19 September 2017

Project Ref: NRC006
MWWUG_Aupouri.doc

Water Permit Application - Motutangi - Waiharara Water User Group (MWWUG), Aupouri Peninsula

Figure 1. Irrigation water requirements for avocados on the Aupouri Peninsula calculated using the Irrigation New Zealand Reasonable Use Database

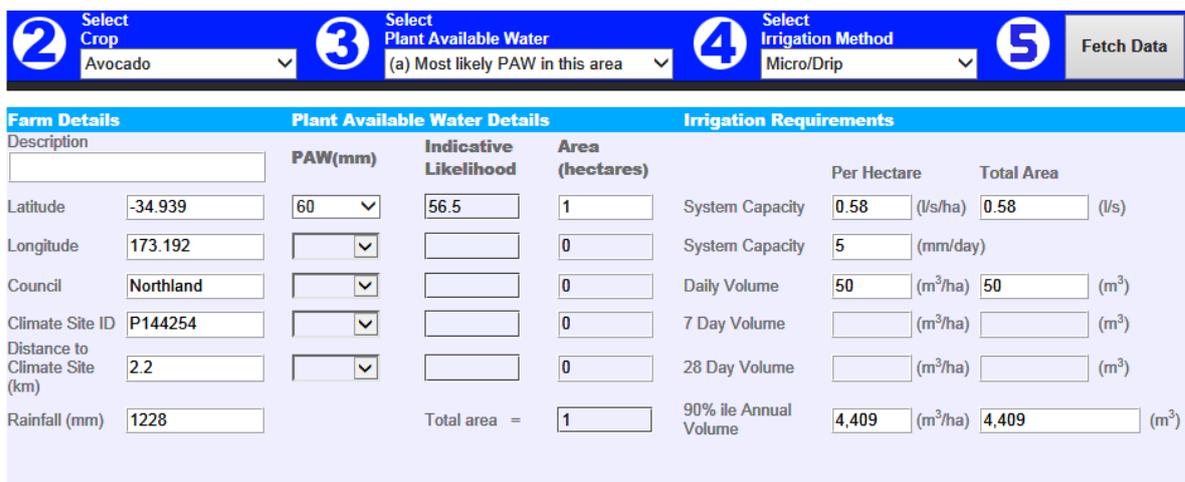
However, as an alternative, Figure 1 shows a screenshot of irrigation water requirements calculated for a sandy soil at a representative site in the Waiharara area (at the corner of Kaimaumau and Far North Road) using the Irrigation New Zealand Irrigation Reasonable Use Database¹². This assessment utilises the Irricalc application to calculate irrigation water demand based local climate data and an assumed soil water holding capacity (in this case 60 mm) for an avocado crop irrigated by micro/drip irrigation. Results of this assessment indicate a maximum daily irrigation demand for avocados of 5.0 mm/day (equivalent to 50 m³/ha/day) and a 90 percentile (i.e. 1 in 10 year maximum) irrigation demand of 441 mm/year (equivalent to 4,410 m³/ha).

Compared to the figures listed in Table 2, all applications have a maximum daily application rates less than that the maximum calculated 1 in 10 year demand. However, five applications (APP.038591.01.01, APP038610.01.01, APP038471.01.01, APP039345.01.01, APP038589.01.01) are seeking annual volumes in excess of the 1 in 10 year maximum annual demand.

Based on the varying estimates of irrigation water use for avocados¹³, the Council may wish to consider if the proposed annual volumes for individual water permits represent reasonable and efficient water use, particularly those which are seeking volumes equivalent to seasonal irrigation depths in excess of 450 mm/year.

Figure 2. Residual head (i.e. difference between minimum 90 day average modelled head and the estimated required head) calculated for Scenario 2

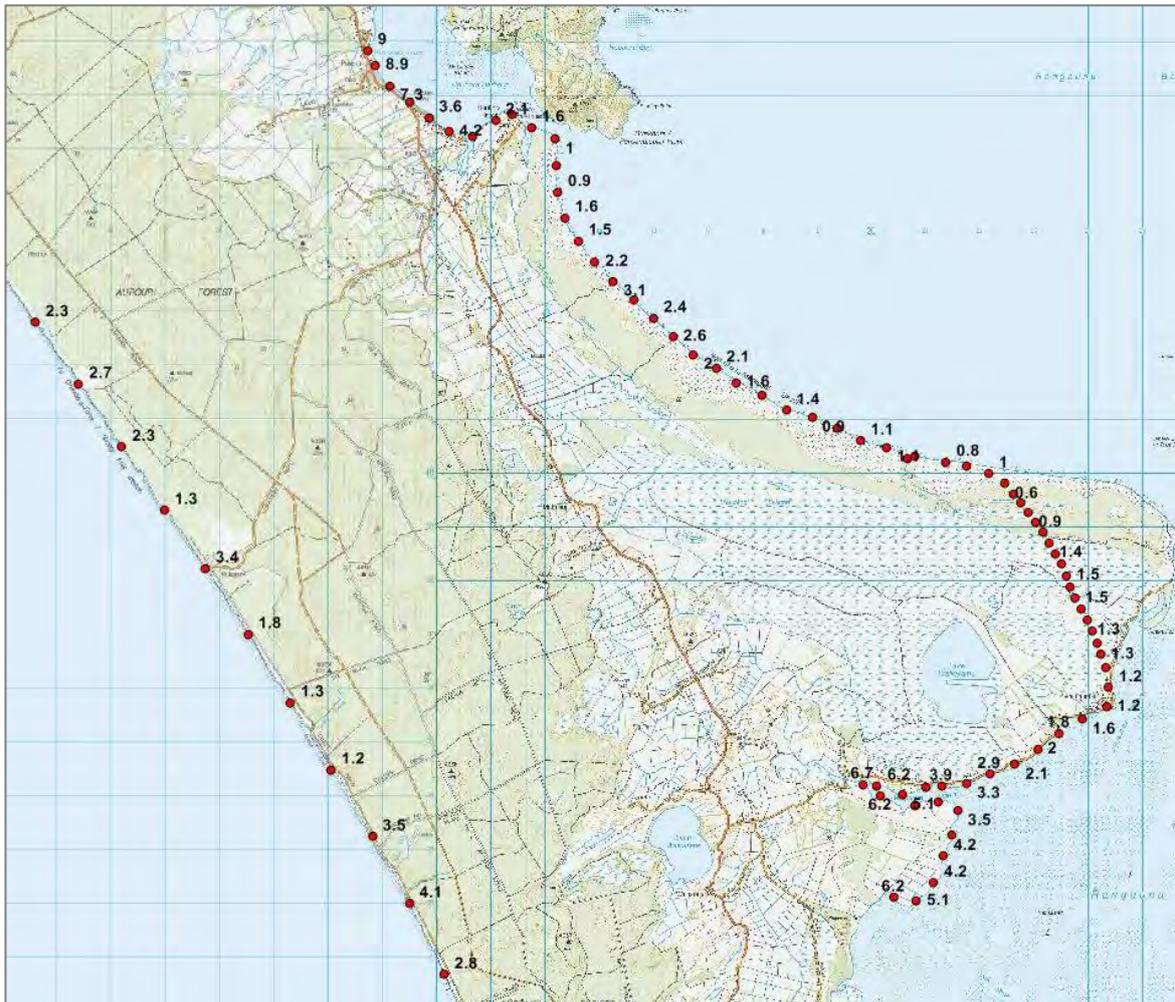
Figure 1 below shows a plot of the calculated residual head (i.e. the difference between the minimum 90 day average modelled head and the estimated required head) for Scenario 2. As illustrated, model results indicate that groundwater levels remain above the required head at all coastal locations indicating the saline interface will be maintained offshore around the entire model domain under the proposed abstraction throughout the 1956 to 2017 simulation period.

Base on the assessment of coastal drawdown calculated for the Scenario 2, the AEE concludes that the potential for saline intrusion to result from the proposed abstraction is no more than minor.

In response to Councils request for further information, Scenarios 4a, 4b and 4c (which assume lower vertical leakage) were evaluated over the 60 year simulation period. Results of these scenarios exhibit progressively lower residual head around the coastal margin (due to increased drawdown simulated in the shellbed aquifer). Under Scenarios 4a and 4b modelled heads are maintained above the required head at all points around the model domain. Under Scenario 4c (which assumes vertical hydraulic conductivity is reduced by three orders of magnitude), the minimum calculated head falls below the required head along the middle section of East Beach¹⁵.
